# Access Compliance Report

### (Curb Ramps)

Intersection ID: 15489	Main Street: HARVARD_PL	Cross Street: QUEENS_RD	Location: E
ADA ID: 71BF1DCFE31C	Ramp Type: Perp	Initial Pass/Fail: Fail	Overall Compliance: No
Severity Score: 72.5			
Codes/Mitigation Info/Possible Solution		Field Measurements/Component Compliance

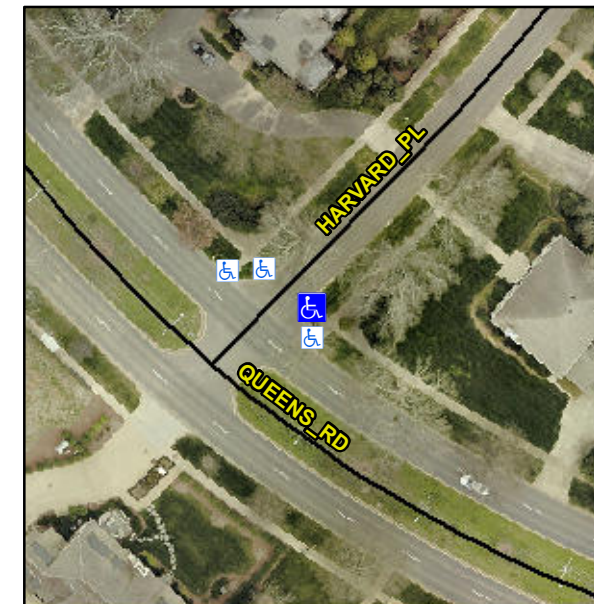
**Not Found, R304.5.1, R304.2.2, R304.5.3**

Compliance	Description	Data	Compliance	Description	Data
N/A	Ramp Length (in)	57.0	No	Ramp Slope (%)	11.0
No	Ramp Width (in)	28.0	No	Ramp XSlope (%)	8.1
N/A	Flare Type LT	N/A	N/A	Flare Type RT	N/A
N/A	Flare Slope LT (%)	N/A	N/A	Flare Slope RT (%)	N/A
N/A	Flare Traversable LT?	N/A	N/A	Flare Traversable RT?	N/A
N/A	Landing Length (in)	N/A	N/A	DWS Provided?	N/A
N/A	Landing Width (in)	N/A	N/A	DWS Contrast?	N/A
N/A	Landing Slope (%)	N/A	N/A	DWS Length (in)	N/A
N/A	Landing X Slope (%)	N/A	N/A	DWS Full Width?	N/A
N/A	Landing Curb? (Y/N)	N/A	N/A	DWS Offset (in)	N/A
N/A	Shared Landing?	N/A			
N/A	Gutter Ponding?	N/A	N/A	Gutter Slope (%)	N/A
N/A	Gutter Lip Ht (in)	N/A	N/A	Gutter X Slope (%)	N/A
N/A	Painted X Walk1?	No	N/A	Painted X Walk2?	N/A
	X Walk 1 Direction	To NW		X Walk 2 Direction	N/A
N/A	X Walk 1 Width (in)	N/A	N/A	X Walk 2 Width (in)	N/A
	X Walk 1 Slope (%)	3.6		X Walk 2 Slope (%)	N/A
	X Walk 1 X Slope (%)	0.9		X Walk 2 X Slope (%)	N/A

**Remove & Replace Entire Ramp.**
